Historic Architectural Review Commission Staff Report for Item 3

Application Number: C2025-0057

Address: 417 Elizabeth Street (rear)

Second Reading - Partial demolition of covered Florida room on south elevation to extend gable roof, removal of deck in north elevation, partial demolition of walls in north elevation to accommodate new addition, and demolition of existing pool.

Proposed Site Plan showing areas to be demolished.

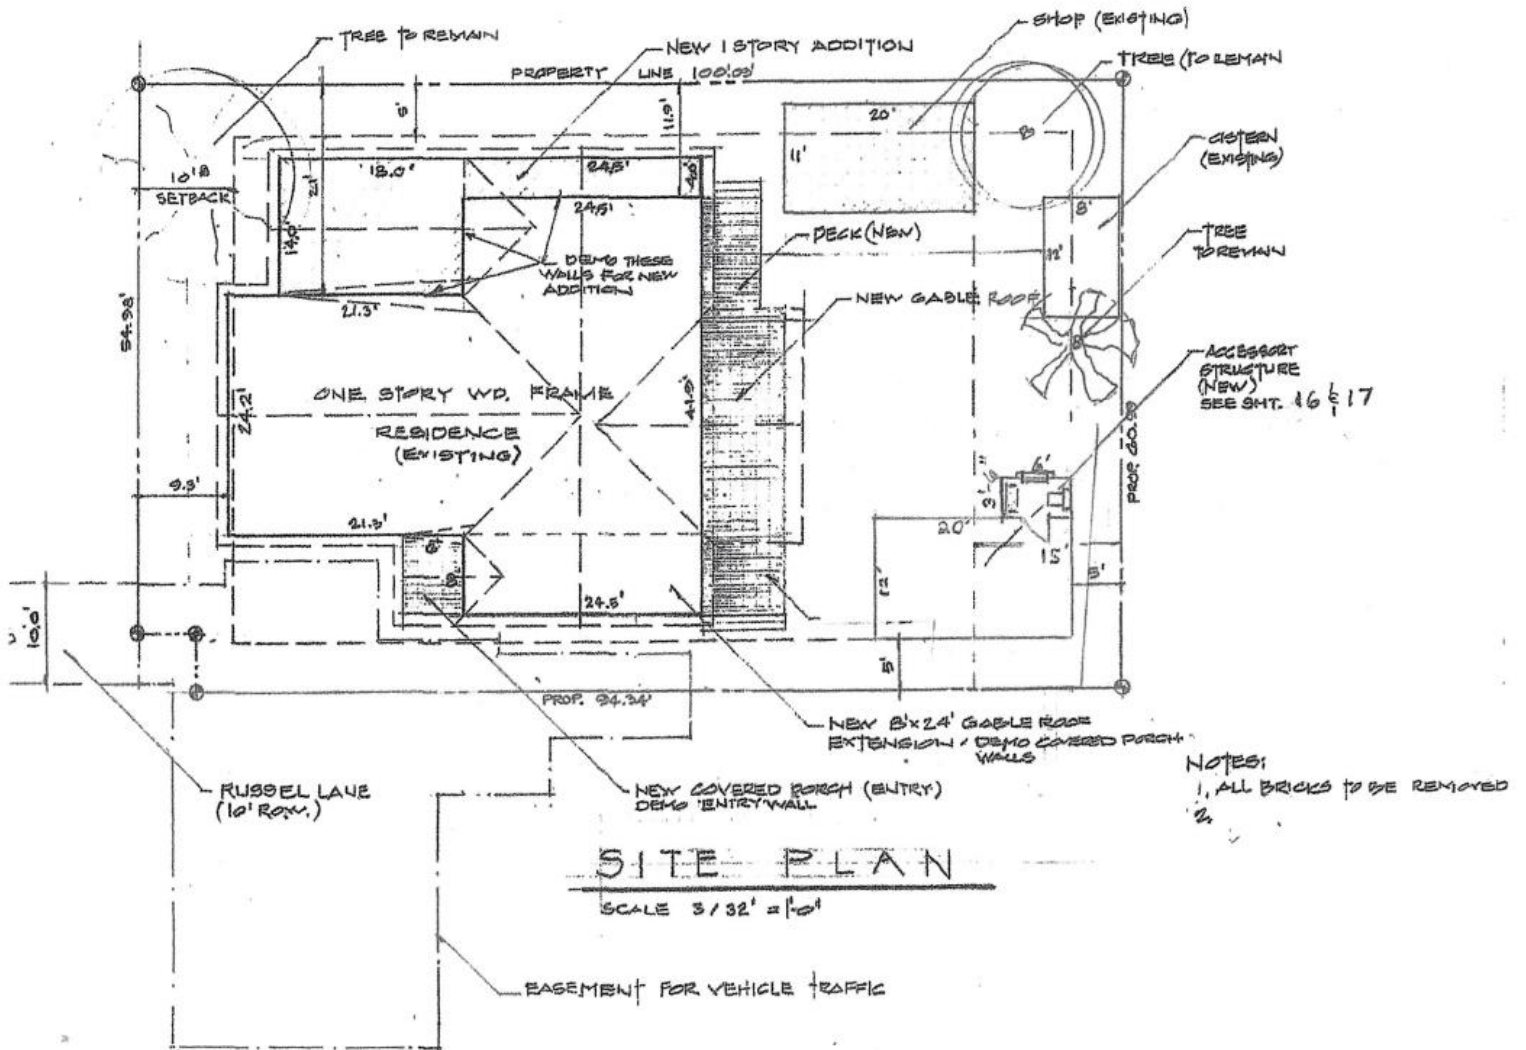
The existing enclosed porch on the south elevation is proposed to be demolished to extend the existing gable roof in the same footprint. On the west elevation facing Russell Lane, the existing entry wall will be removed to allow for the construction of a new covered front porch. The north elevation will undergo demolition of the existing porch and adjacent exterior walls to accommodate the new one-story addition. A portion of the existing roof on the east elevation will be removed to integrate the proposed covered porch. The existing pool is proposed to be removed. Additionally, the existing brick on site will also be removed on east and west sides.

It is staff opinion that the request for demolition can be considered as it meets the criteria for demolition, however, taking into account that the contributing structure does not exhibit extreme deterioration. If approved, this will require two readings for demolition as the building is contributing to the historic district. Staff will review submitted construction plans for demolition and design to assure consistency with submitted drawings.
